STAFF RECOMMENDATION
1228 4TH Avenue North
August 19, 2020

Application: Final SP Review—Infill
District: Germantown Historic Preservation Zoning Overlay
Council District: 19
Map and Parcel Number: 08209032200
Zoning: SP
Applicant: Matt McCreary and Brian Haun, Allard Ward Architects
Project Lead: Melissa Baldock, melissa.baldock@nashville.gov

1 Front Units: West Elevation
 Scale: 3/32"=1'-0"

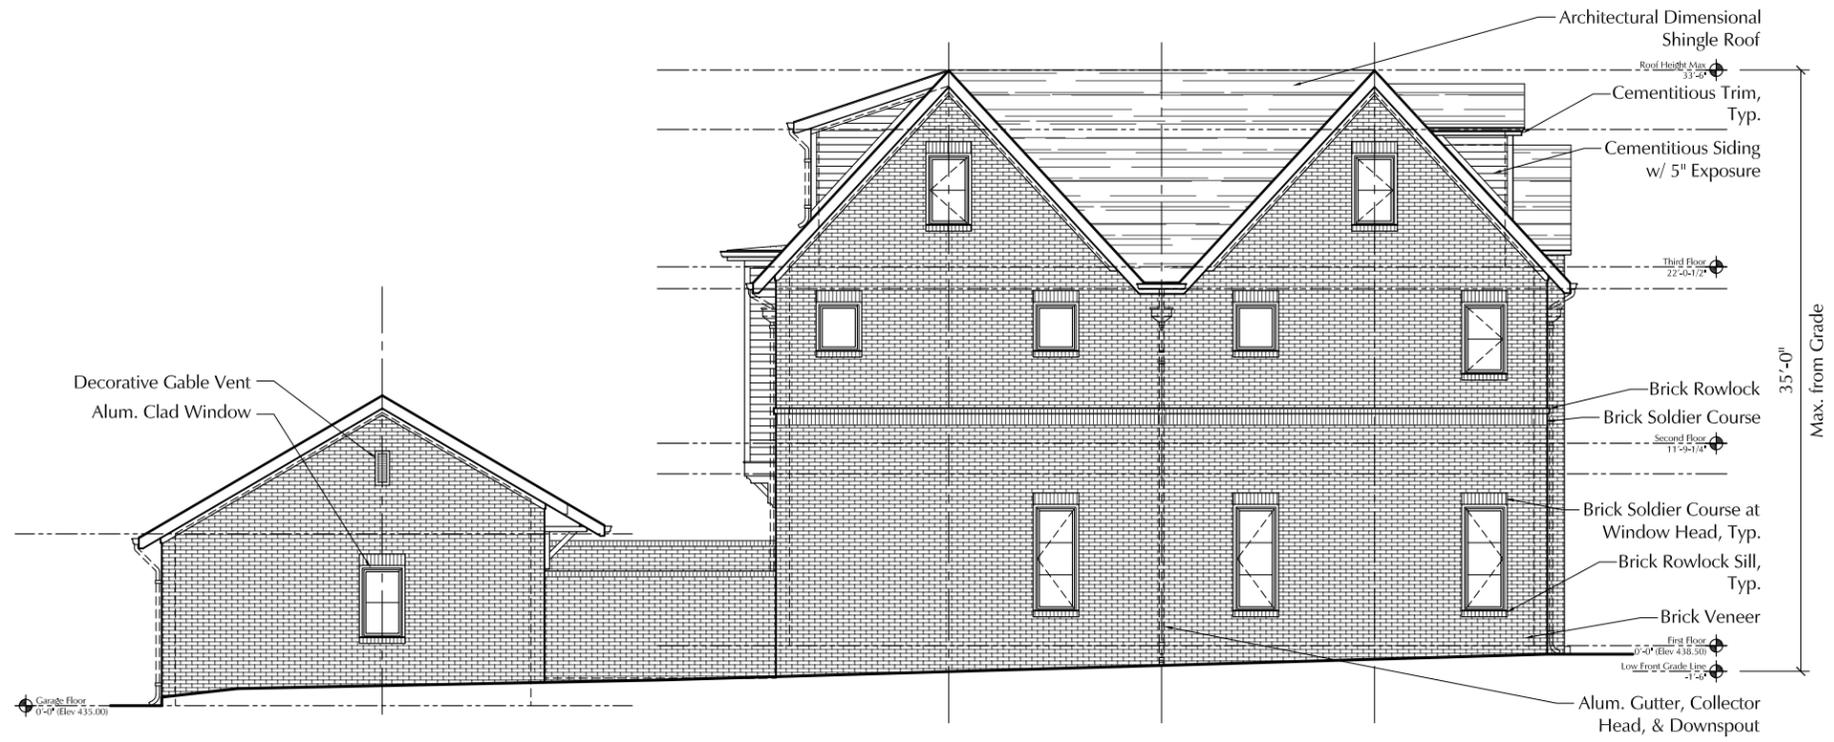
Height and Scale: The height and scale of townhouse development is similar to what MHZC approved in its preliminary SP review, with a few exceptions. One exception is that the front facades of the townhouses along 4th Avenue North now include gabled dormers. Staff finds that the addition of the dormers increases the overall perceived scale of the townhouses and does not meet the design guidelines. The design guidelines state that new construction can be up to two-stories and thirty-five feet (35') in height. Staff finds that the front dormers enlarge the scale of the townhouses to be more akin to two-and-a-half stories. Staff recommends that the dormers on the 4th Avenue North façade be removed so that the scale of the townhouses remains two story.

Materials: The primary cladding material is brick, which meets the design guidelines. Staff recommends approval of a brick sample. Staff also recommends the incorporation of a brick rowlock, soldier course, or another brick detail at the foundation line. All of the facades are at least eighty percent (80%) brick. Fibercement lap siding, with a maximum reveal of five inches (5") will be used for the dormers and bays. Some windows and the doors on the front of the 4th Avenue North townhouses will have limestone surrounds. Staff recommends approval of a stone sample. Accent tile will be used within the entry vestibule, and staff recommends approval of the tile. All trim will be cement fiberboard. The windows will be aluminum clad. Staff recommends approval of all windows and doors prior to purchase and installation. The main roof will be architectural dimensional shingles, and staff recommends approval of the shingle color and texture prior to purchase and installation. Parts of the roof with a low slope will be EPDM roofing, which is appropriate because it will not be highly visible.

Roof: The roof forms were approved by MHZC in the preliminary SP review. As mentioned under "Height and Scale," the drawings submitted for the Final SP review differ from the previously approved forms in two ways. One, the detached garages in the middle of the lot now have gabled roofs rather than roofs that are part gable, part flat. Staff finds this to meet the design guidelines. Two, the 4th Avenue North townhouses now have gabled dormers facing 4th Avenue North. Staff recommends that these dormers be eliminated, as they increase the perceived height from two stories to two-and-a-half stories.

With the elimination of the dormers on the 4th Avenue North façade of the front building, staff finds that the development's roof forms to meet Section III.E.8. of the design guidelines.

1. The dormers on the front façade be removed;
2. A brick rowlock, soldier course, or other design detail be included at the foundation line;
3. The brick walls have a maximum height of 6' from grade, as measured from the back of the townhouse;
4. Staff approve a brick sample, stone sample, tile sample, all windows and doors, the roof shingle color, the exterior lighting fixtures, the walkway and driveway materials, and all other materials prior to purchase and installation;
5. Staff approve the location of HVAC; and,
6. A new brick public sidewalk to match the historic brick sidewalks of Germantown be installed in front of the development.

Front Unit Garages: East Elevation

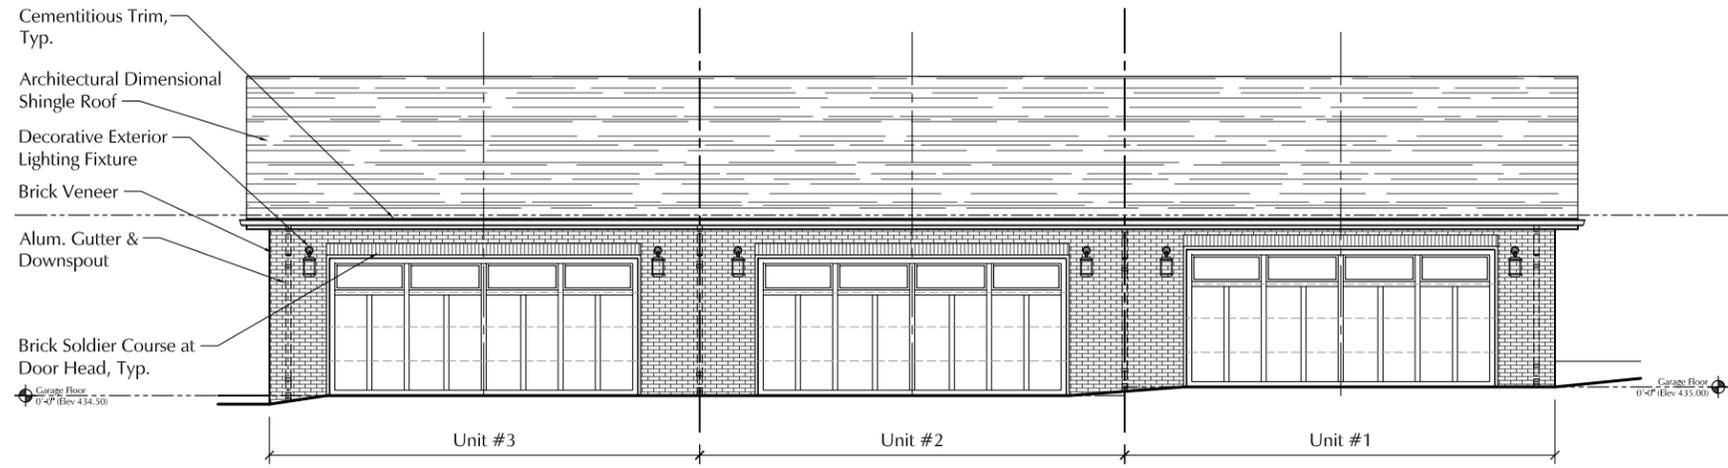
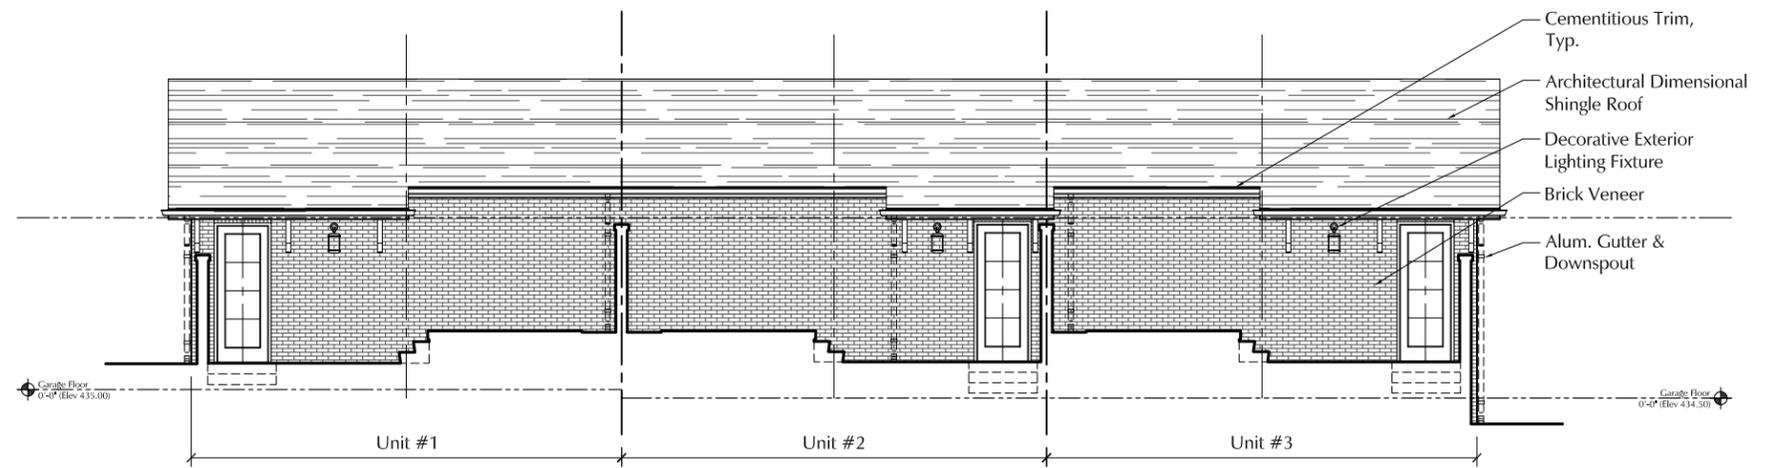
The roof form and the overall height of the detached garages in the middle of the site has decreased from what was approved in the preliminary SP review. In the preliminary SP, the detached garages had a combination of a flat and gable form with a maximum height of nineteen feet, seven inches (19'7"). In the final SP plans, the garage roofs are entirely

gabled, and their heights have been reduced to approximately sixteen feet (16'). Staff finds that this roof form and overall height meet the design guidelines.
